Cundy Street Quarter

Transport Assessment Addendum

Transport Assessment Addendum

23/10/2020

Drawing Title
**CUNDY STREET
PASSING POINT AND
IMPACT ON EXISTING PARKING**

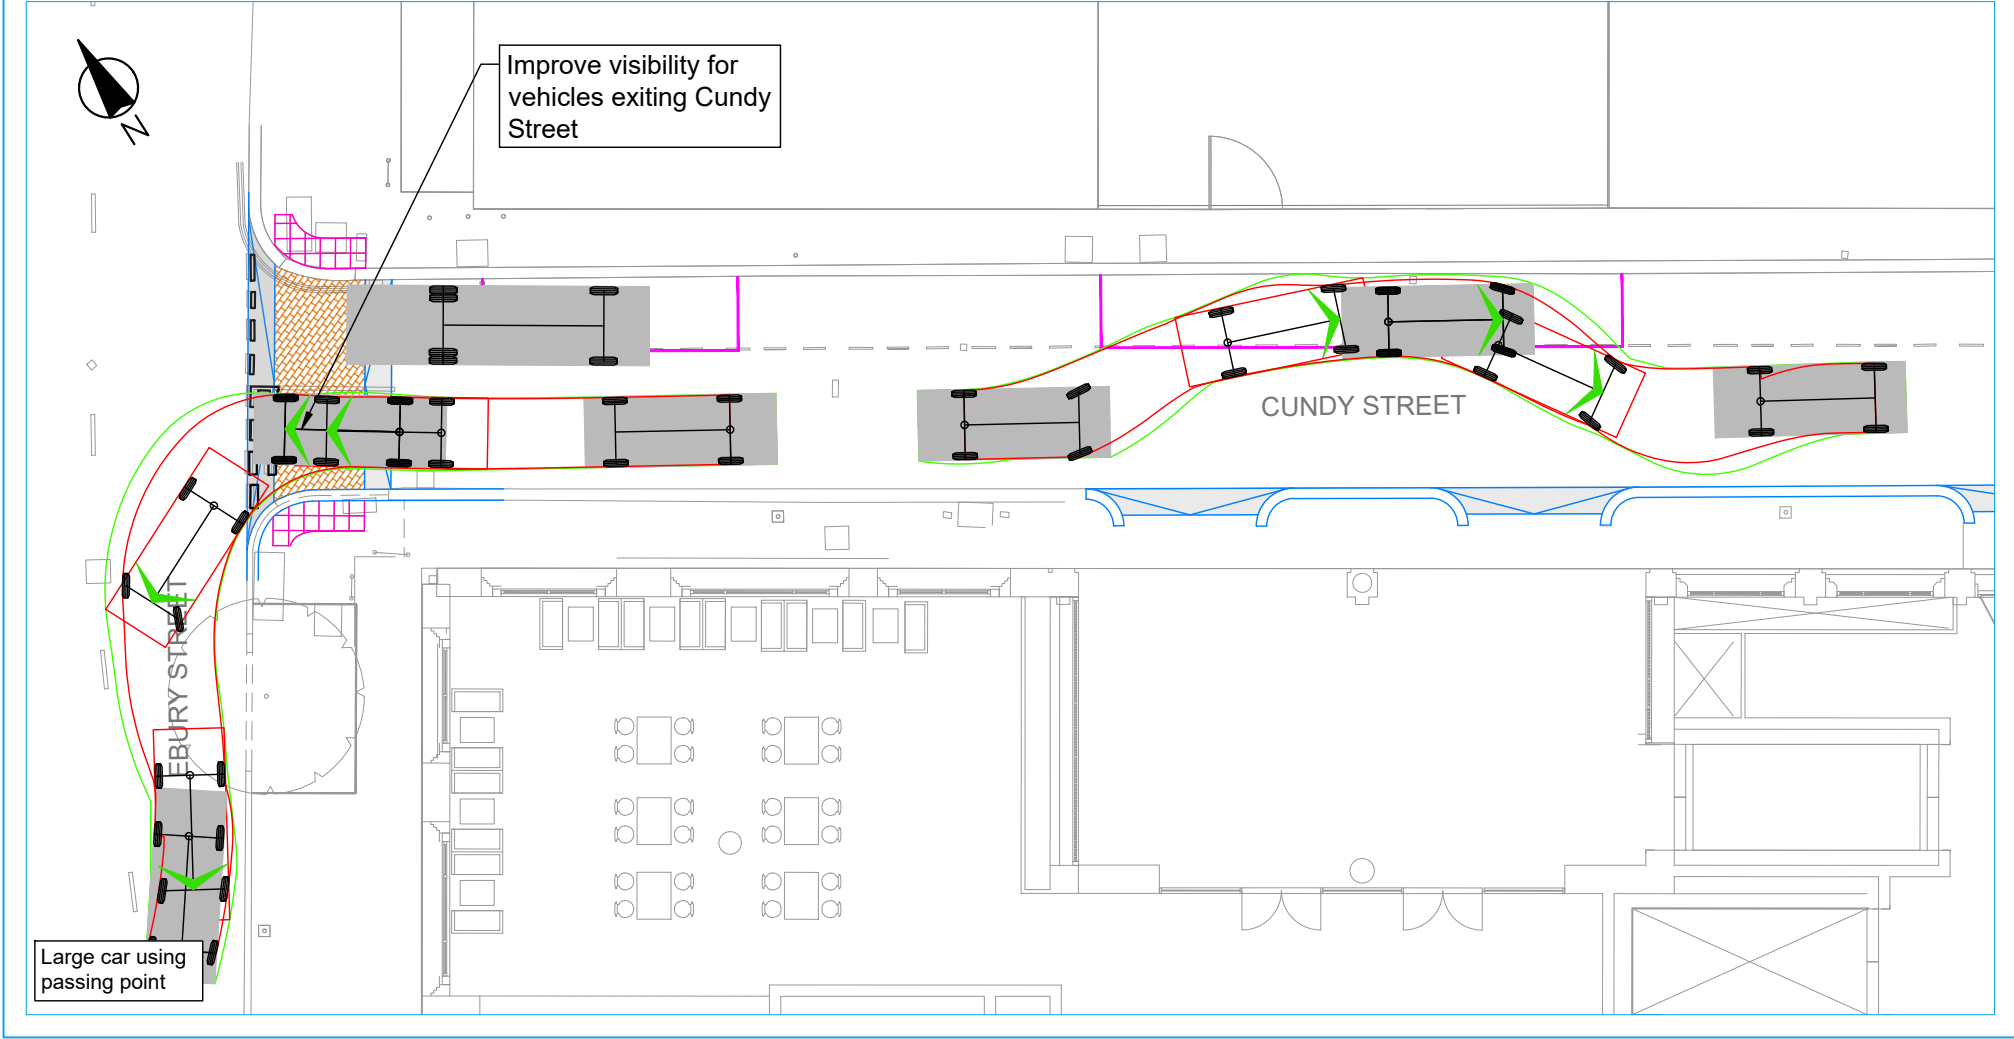
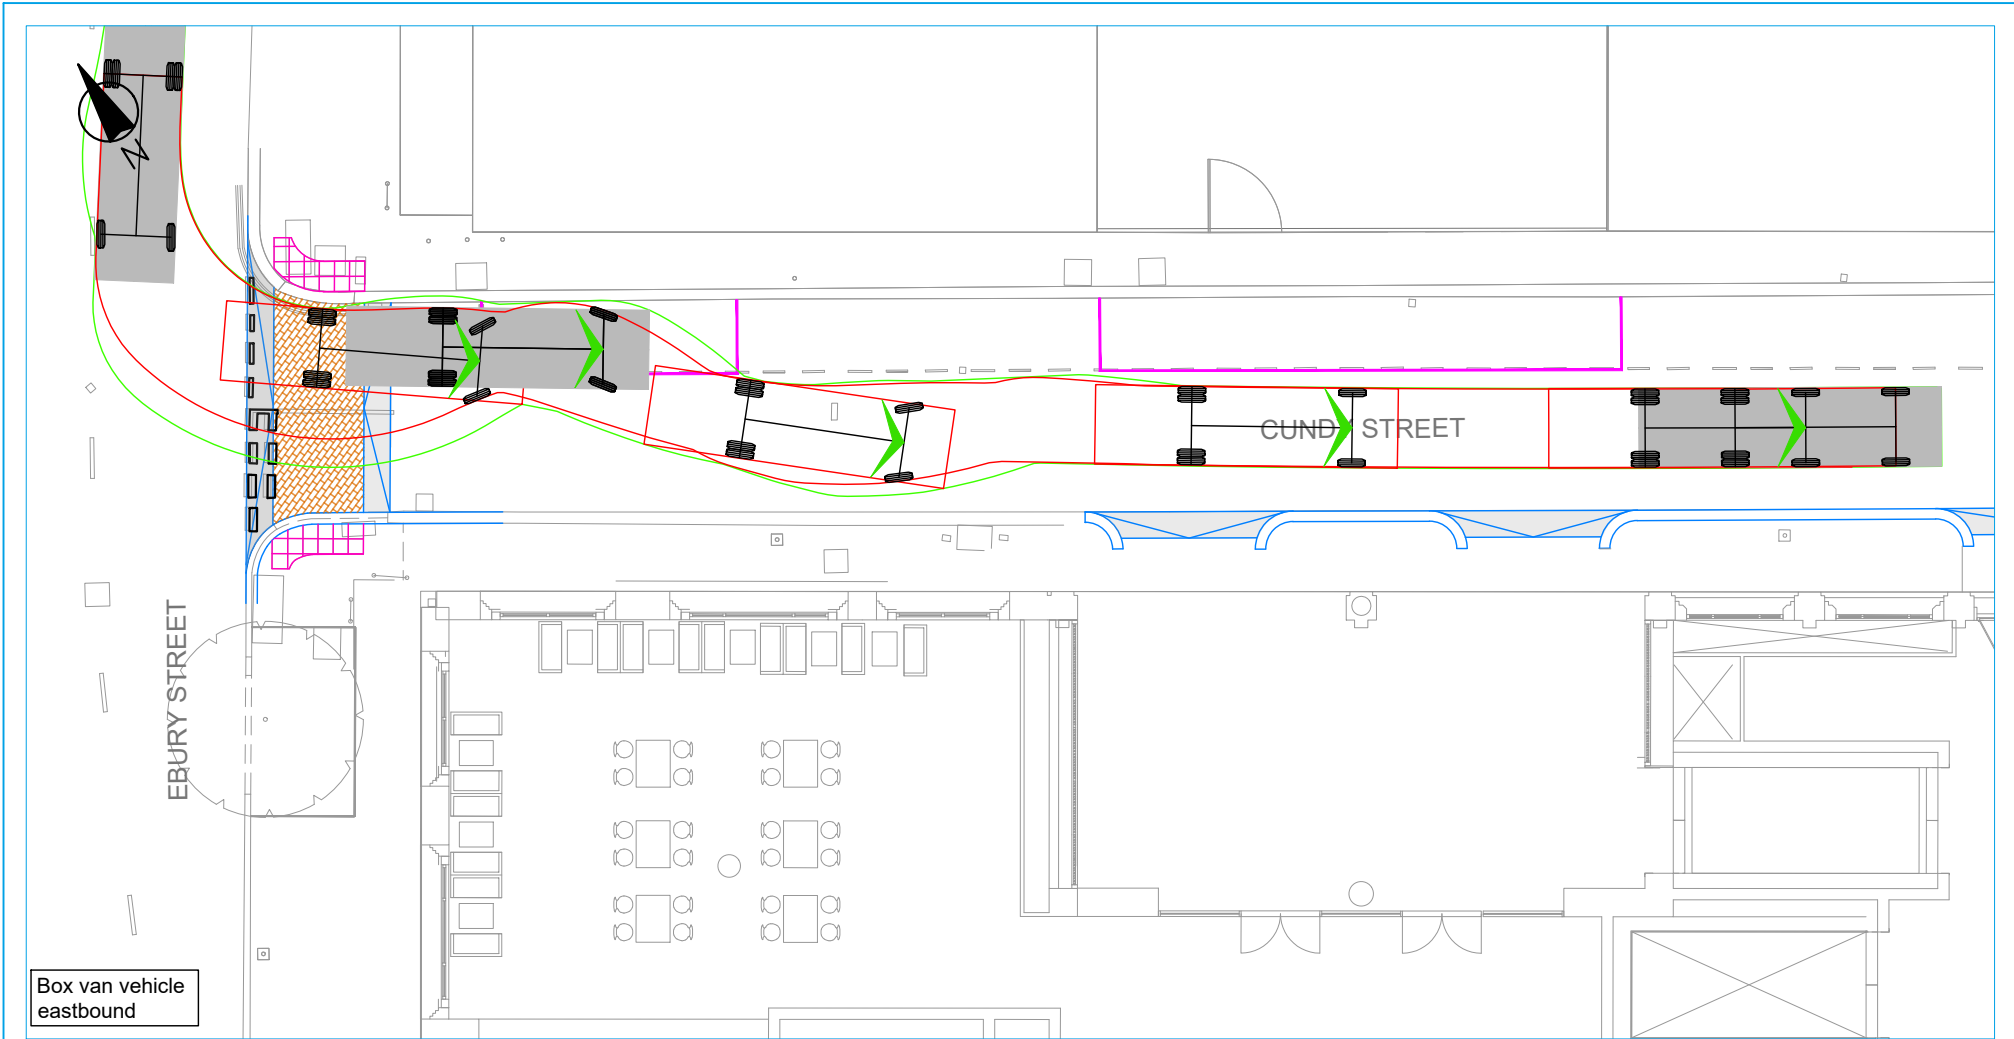
- 2.2.2 Drawing M000483-2-2-DR-024 (provided as Appendix A) illustrates the proposed alternative configuration for Cundy Street. The alternative carriageway arrangement would result in the relocation of three (3) residential parking bays from Cundy Street instead of ten spaces as proposed in the Transport Assessment.

- 2.2.3 The relocation of three (3) residential permit bays from Cundy Street would provide improved vehicle passing opportunities for the two-way flow permitted on Cundy Street. A vehicle passing point would be provided adjacent to the junction of Cundy Street and Ebury Street (overcoming the current need to stop and block southbound traffic on Ebury Street, on occasions). A secondary passing location would be provided in a central location on Cundy Street opposite the proposed Building A Drop-off as shown in Drawing M000483-2-2-DR-025 (provided as Appendix A).

APPENDIX B: EBURY SQUARE & AVERY FARM ROW REVISED HIGHWAY ARRANGEMENT

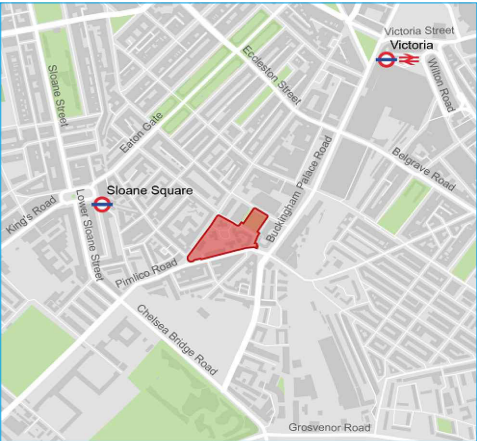
- 3.2.1 Following feedback given by the Metropolitan Police, post submission relating to the proposed raised crossing across the eastern section of Ebury Square impacting police vehicles existing Belgravia Police Station in emergencies, it is now proposed that the raised surface treatments be limited to two locations, these being:

- South-west corner of Ebury Square; and
 - South-east corner of Ebury Square in the east-west direction of travel
- 3.2.2 The revised proposals no longer seek to provide a raised surface treatment in the south-east corner of Ebury Square in the north-south direction of travel.

- 3.2.3 The revised proposals do however seek to maintain dropped kerbs and tactile paving in this location. This represents a balanced design approach that will maintain existing emergency access whilst improving pedestrian amenity and accommodating future east to west pedestrian desire lines.

- 3.2.4 Drawing M0000483-2-2-DR-010-D (provided as Appendix B) shows the revised streetscape proposals for Ebury Square.
